Table Encoder Cable Interference

MQUE-5ANGVW

All HiSpeed and LightSpeed Products Using the Zeus Table

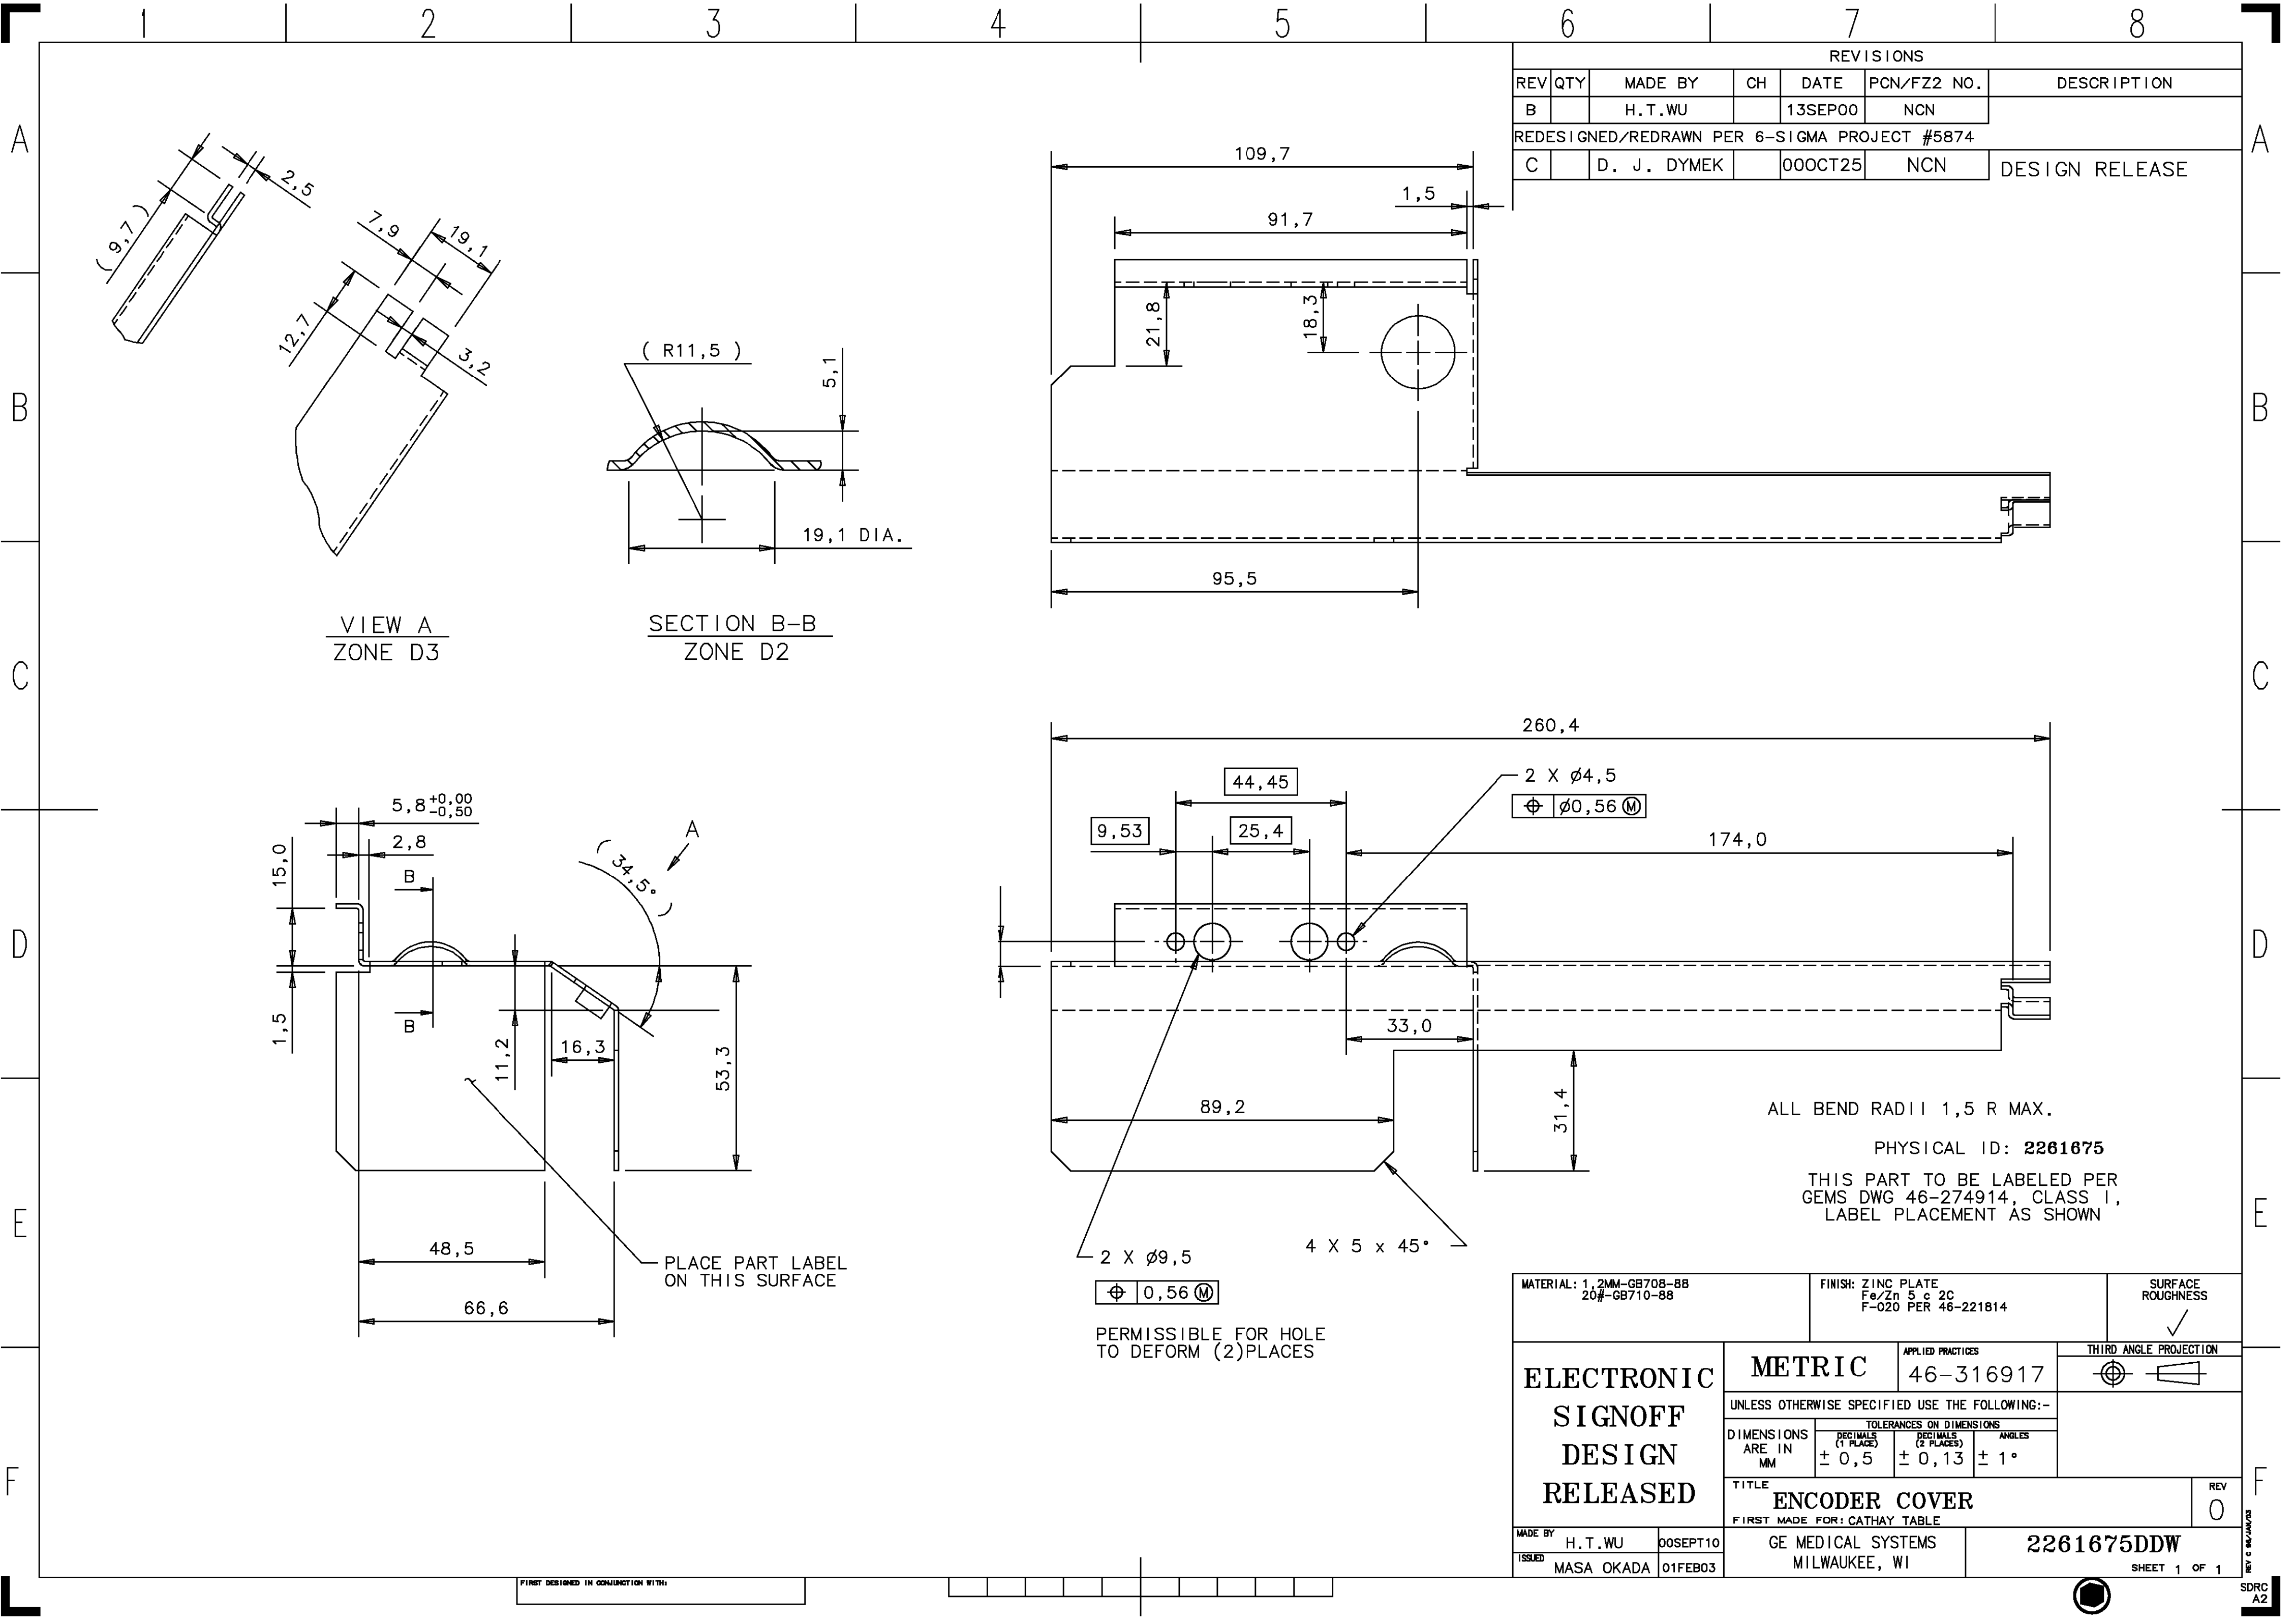
The table longitudinal encoder cable can be snagged near the gantry end of the table by customer-introduced obstructions. This often results in damage to the encoder assembly through "sudden spool unwind" and the cable being knocked off of the spool.

A new cover has been designed to protect the cable and add some additional clearance for the spool. This was to be introduced on the LightSpeed Plus systems; however, 214 tables were manufactured using the old cover. It is recommended that the old cover (46-297897P1) be replaced with this new cover (2261675). It was the result of a Six Sigma project and was found to dramatically reduce the frequency of these types of failures. The cover is compatible with and can be installed on all flavors of the Zeus table. The cost is minor and it is recommended that you order the new cover to replace your old cover on your next pm. Drawings of the two covers are included below for reference.

ENCODER COVER

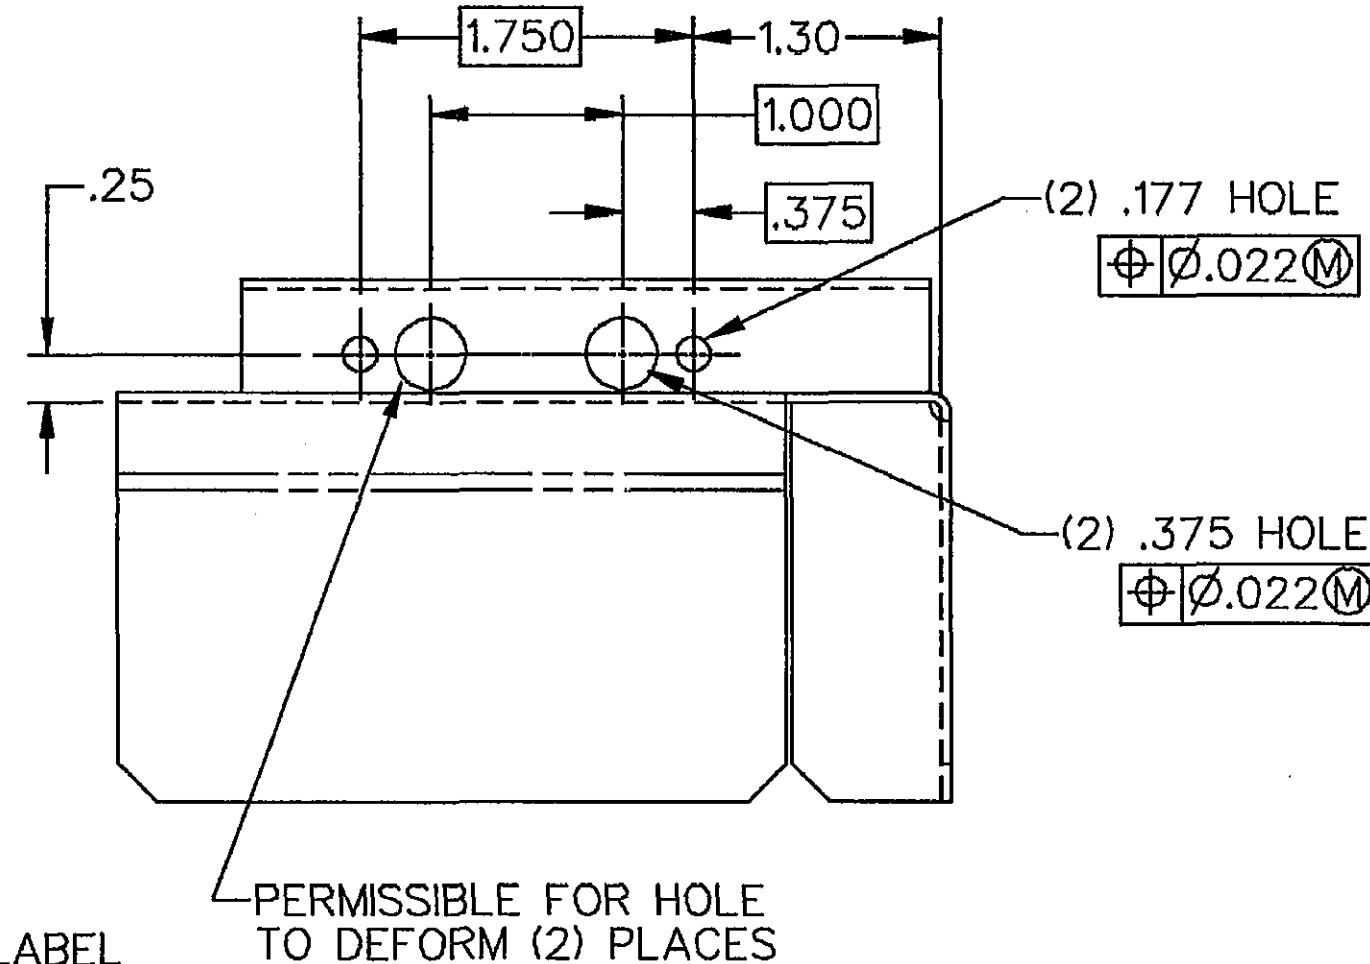
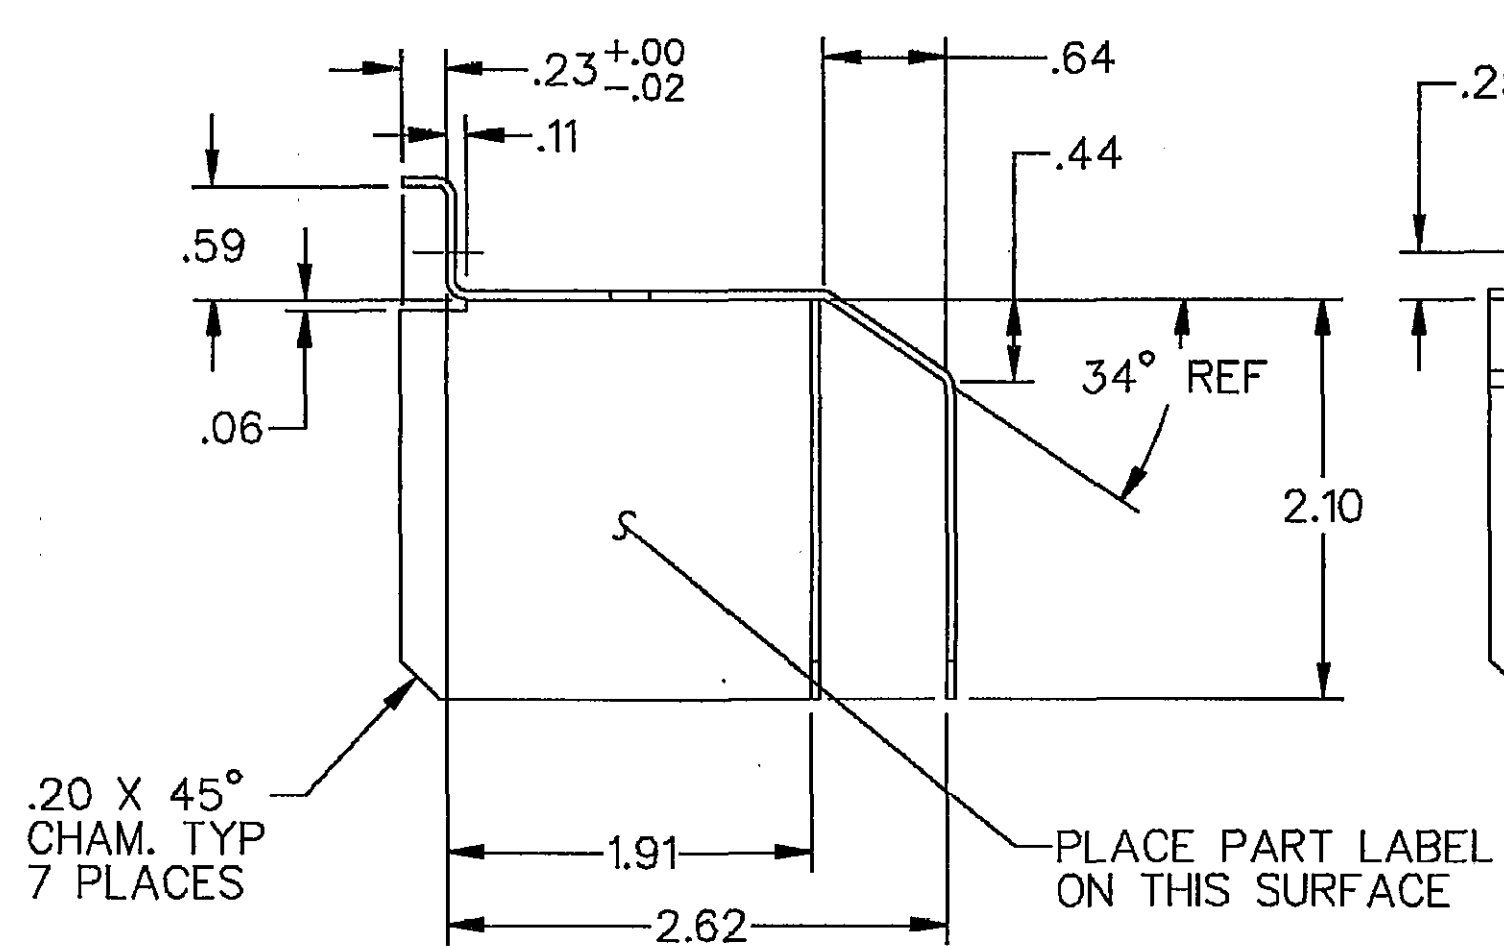
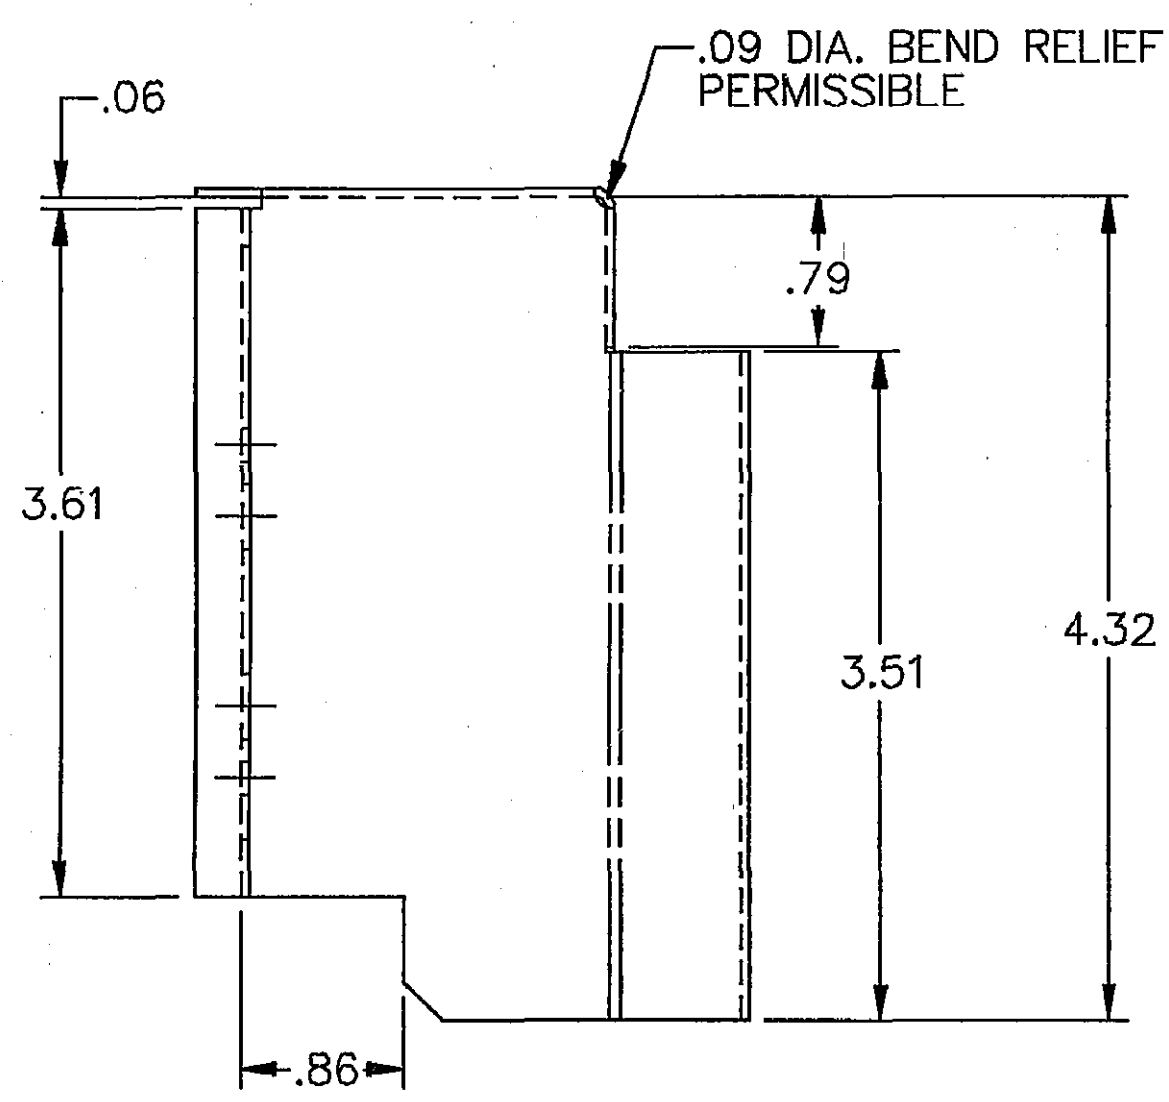
REVISIONS			PRINTS TO	
B	JOE ROBINETTE 92JUN19	NCN	500	
REMOVED WELD, .06, .16 & .11, REVISED PART LABEL, .79-WAS-.73, ADDED .09 DIA. BEND RELIEF PERM. .25 & HOLE DEFORM PERM. REMOVED .34, .23-WAS-.24
